**PLANNING COMMISSION
MEETING AGENDA
REGULAR MEETING**

5. PRELIMINARY SITE PLAN APPROVAL – (SP JPLN2025-0001) – Proposed GFA Forsyth Site Condominium, 9 single family detached units, North of Wattles, West of Dequindre (4189 and 4197 Forsyth; PIN 88-20-13-401-028, -037 & -038), Section 13, Presently zoned R-1C One Family Residential Zoning District.

Preliminary Site Condominium Review For City of Troy, Michigan

Project Name:	GFA- Forsyth
Applicant:	Gary Abitheira
Plan Date:	April 30, 2025
Location:	4165, 4189, & 4197 Forsyth Drive
Zoning:	R-1C, One-Family Residential District
Action Requested:	Preliminary Site Plan Review

NOTE:
MINIMUM HEADER SIZE TO BE (2) 2X10'S
FOR OPENINGS UP TO SIX FOOT IN
LENGTH UNLESS NOTED OTHERWISE.

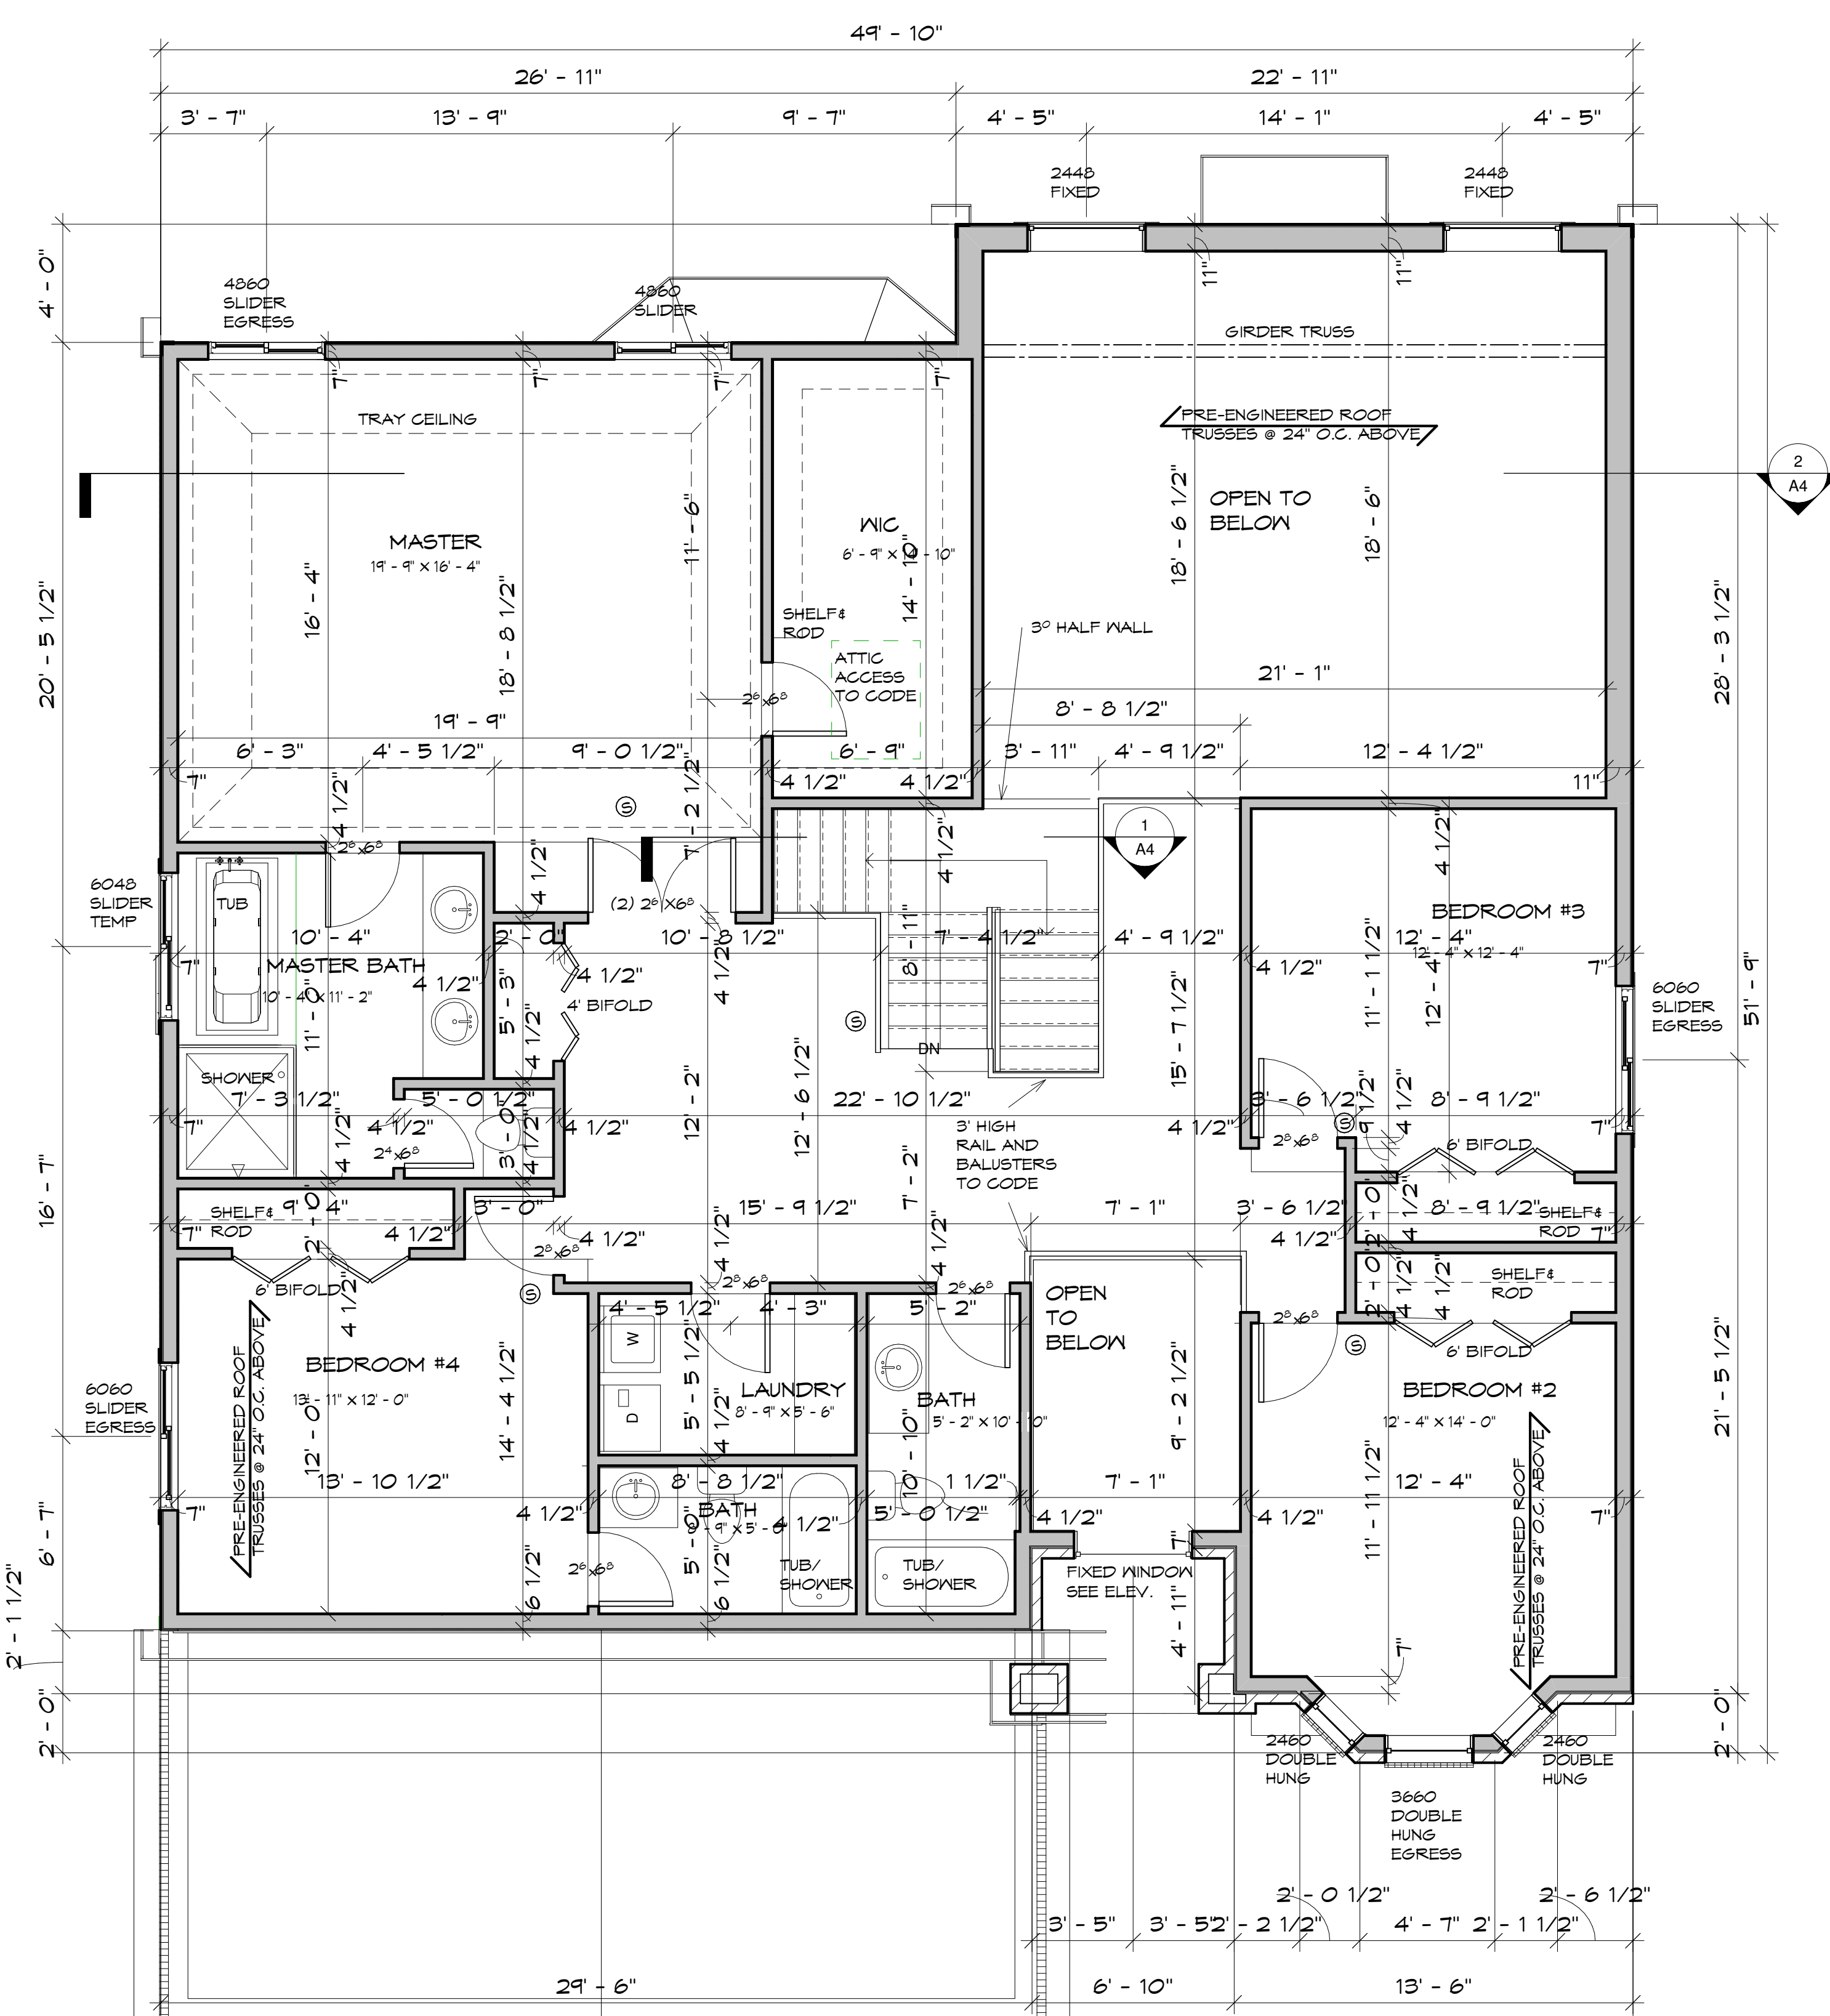
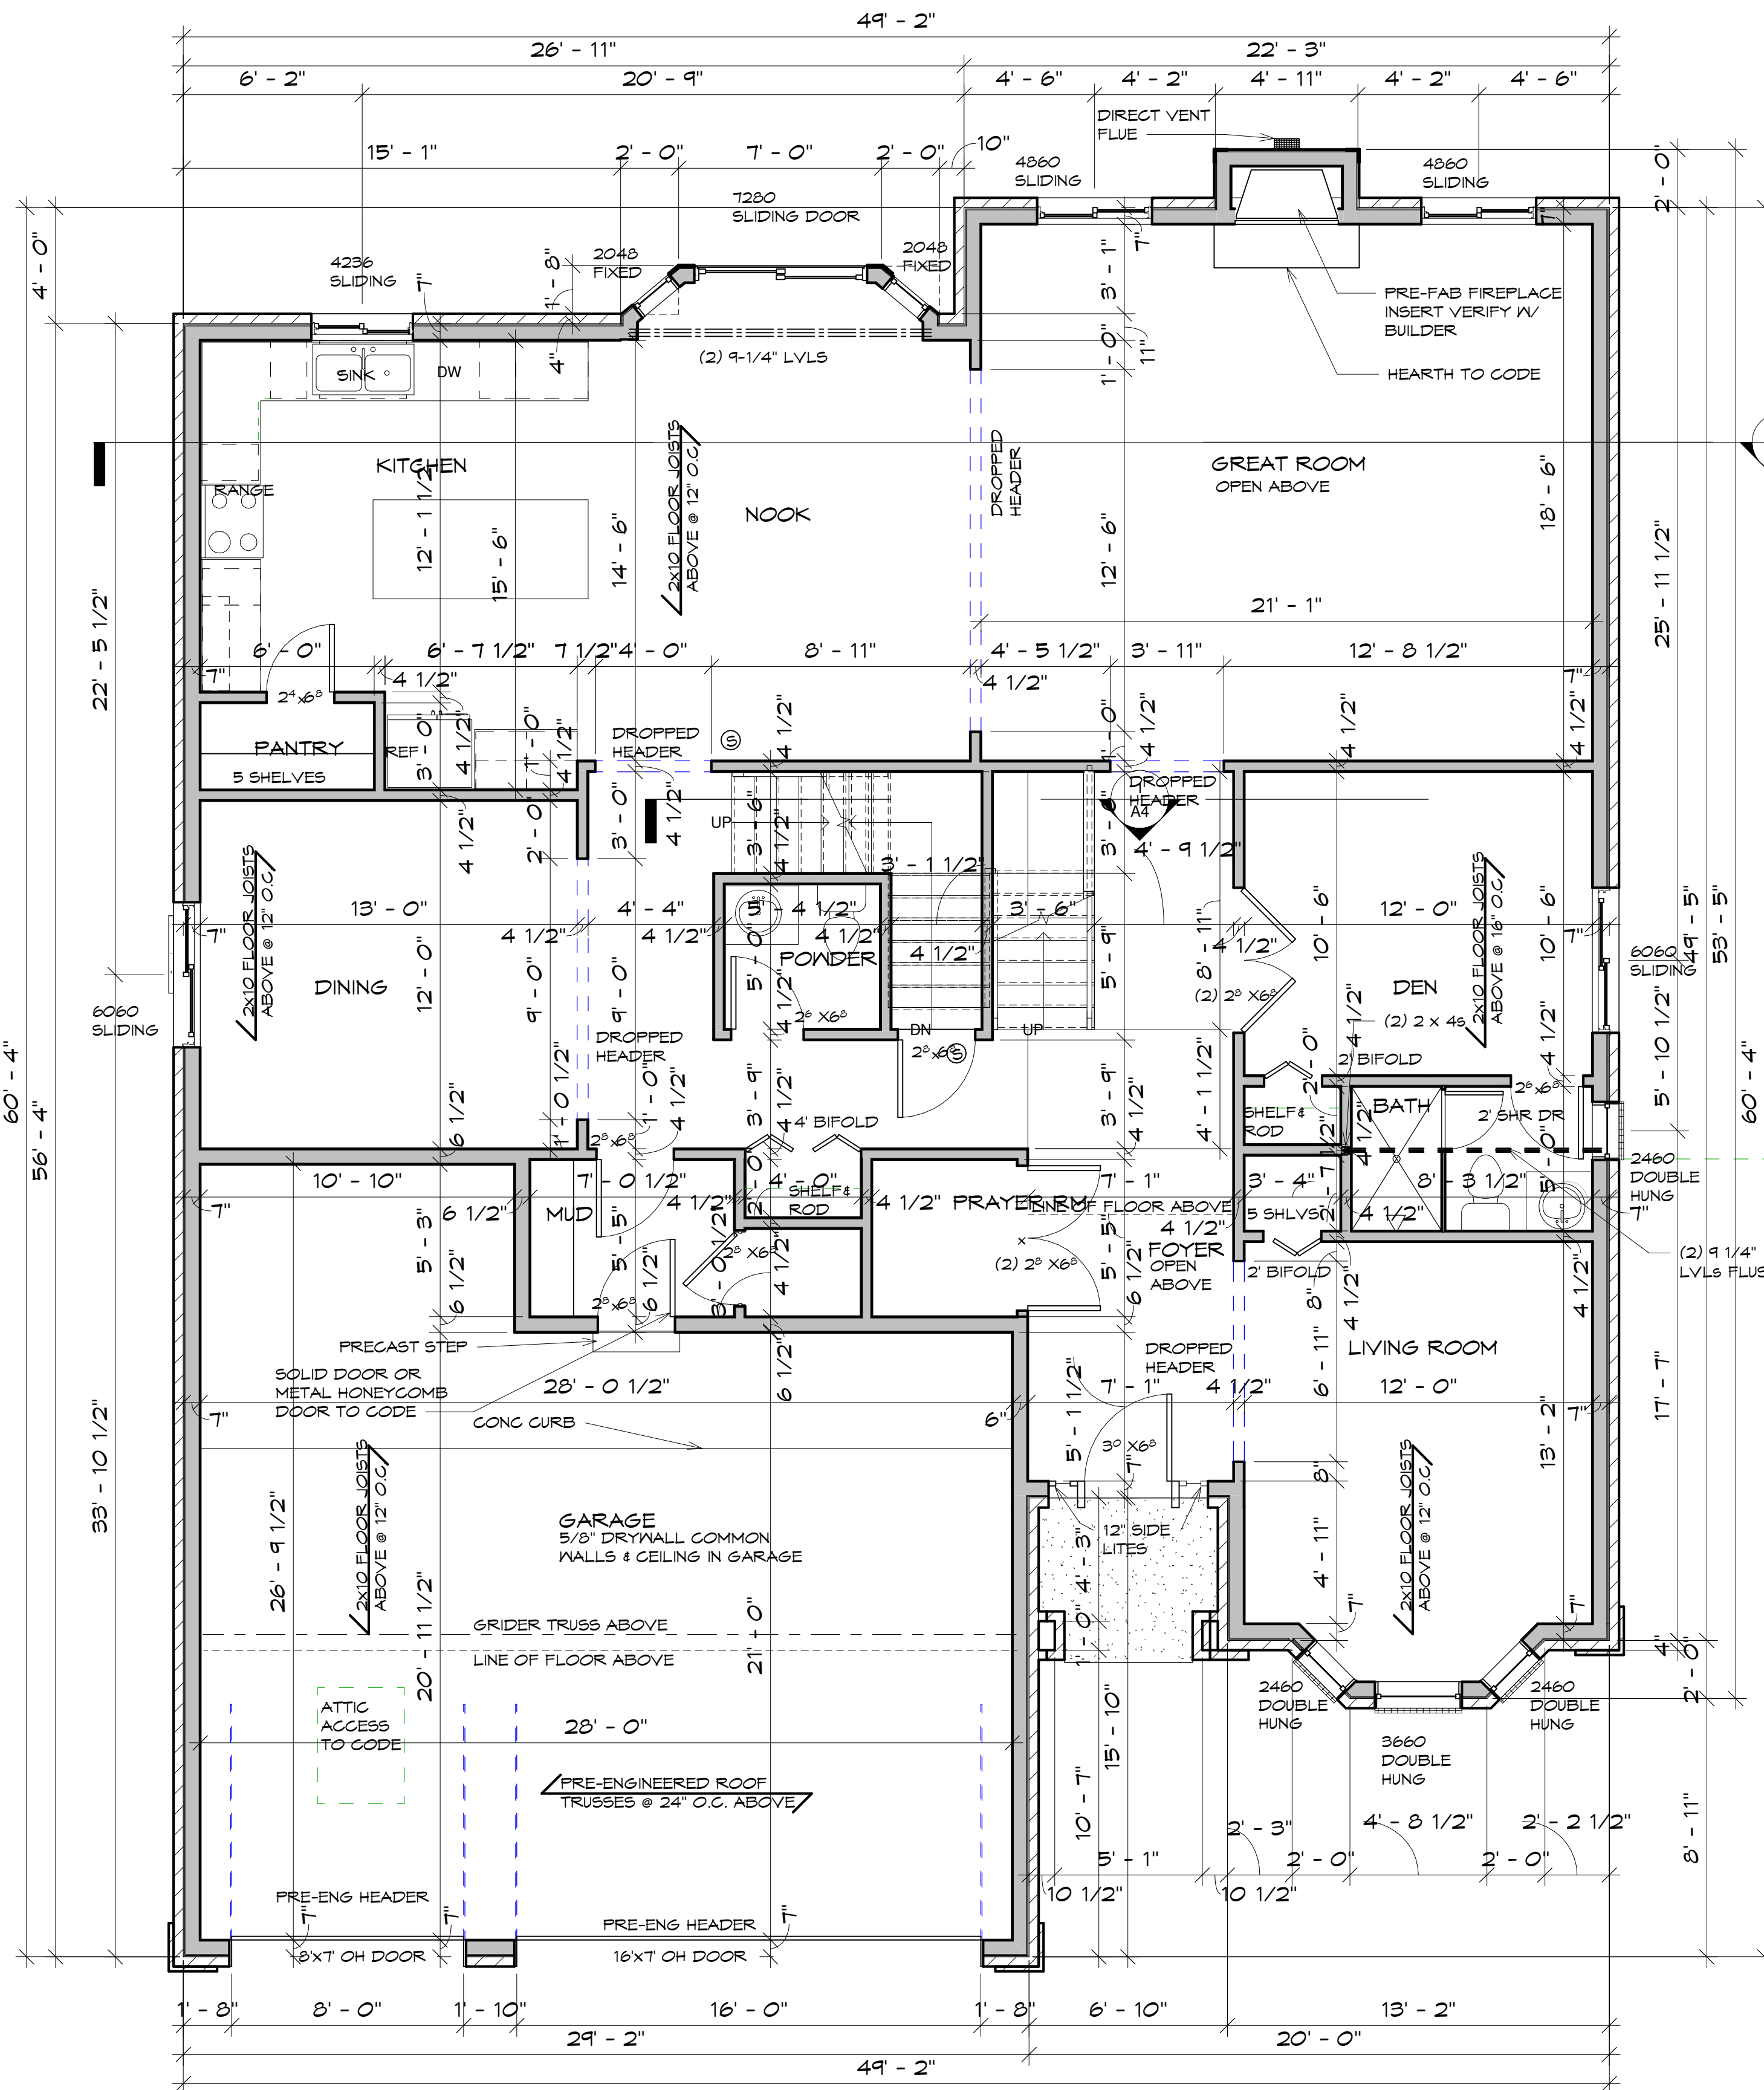
The applicant has provided floor plans and elevations for two (2) housing types, referred to as “The Troywood” and “Vanderpool.”

Both housing types contain a 3-car garage, four (4) bedrooms, and four (4) restrooms. Site plans show the area of the Troywood as 3,549 square feet, however the area of the Vanderpool is not indicated.
